DEPARTMENT OF THE ARMY
HEADQUARTERS, US ARMY COMMUNICATIONS-ELECTRONICS COMMAND
AND FORT MONMOUTH
FORT MONMOUTH, NEW JERSEY 07703-5000

SUBJECT: INSPECTION NO. 030-05248/97-001

Building ^{EX 2} Calibration Range

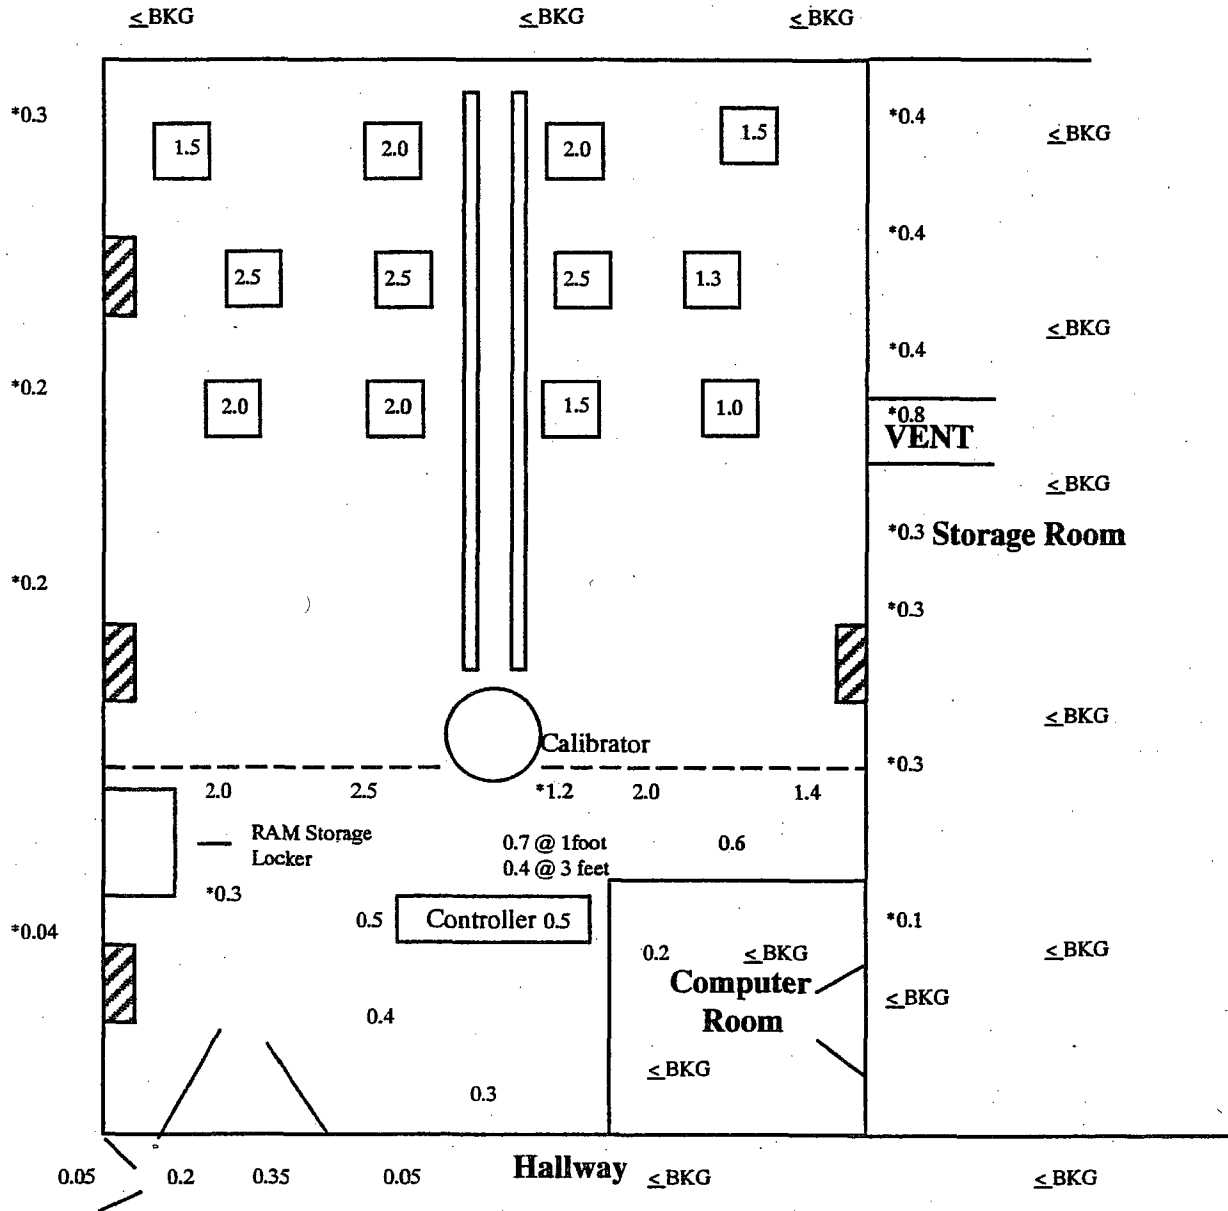
Based on our discussion at the conclusion of the inspection and the results of the radiation survey conducted by representatives from J.L. Shepherd with Steven Shaffer of this office on the exterior of Building 2540, we have determined that an amendment to your license is required prior to use of the 130 curie cesium-137 calibration source. The survey detected radiation levels greater than 2 millirem per hour, the limit for unrestricted areas, outside the boundaries of the facility when the 130 curie source is fully exposed. We understand from your correspondence dated October 6, 1997, that you have electronically disconnected the source to prohibit its use until you install additional shielding. We further understand that you will conduct radiation measurements of Building 2540 before using the 130 curie source for calibration, and will amend your license to show that your facility is adequately shielded and/or controlled to meet the applicable regulations in 10 CFR Part 20 when this source is in use. If any of our understandings are incorrect, please inform us in writing.

As a result of your October 16, 1997 letter to us regarding
the use of the J.L Shepherd and Associates Model 81-14Q in
Building [] an additional collimator has been permanently installed to further collimate the radiation beam. As a result of this action, no additional shielding or changes to the existing structures had to be made. During the week of November 24, 1997, the J.L Shepherd and Associates representative re-calibrated and re-certified this calibrator for use with the 130 curies (Ci) of Cesium-137 (Cs-137) and is currently capable of operating at this activity. Radiation measurements of Building [] has been performed and are provided at enclosure 2 for your information. This survey reveals that our calibration facility is controlled to meet the requirements of Title 10, Code of Federal Regulations, Part 20. Roof access points have been posted and access to the roof is not authorized while the calibrator is in use. Ex 2 Ex 2

Based on the above and since regulatory compliance has been achieved without modifying the building construction or adding additional shielding, we will, as necessary, begin to utilize the 130 Ci Cs-17 source in support of our calibration mission.
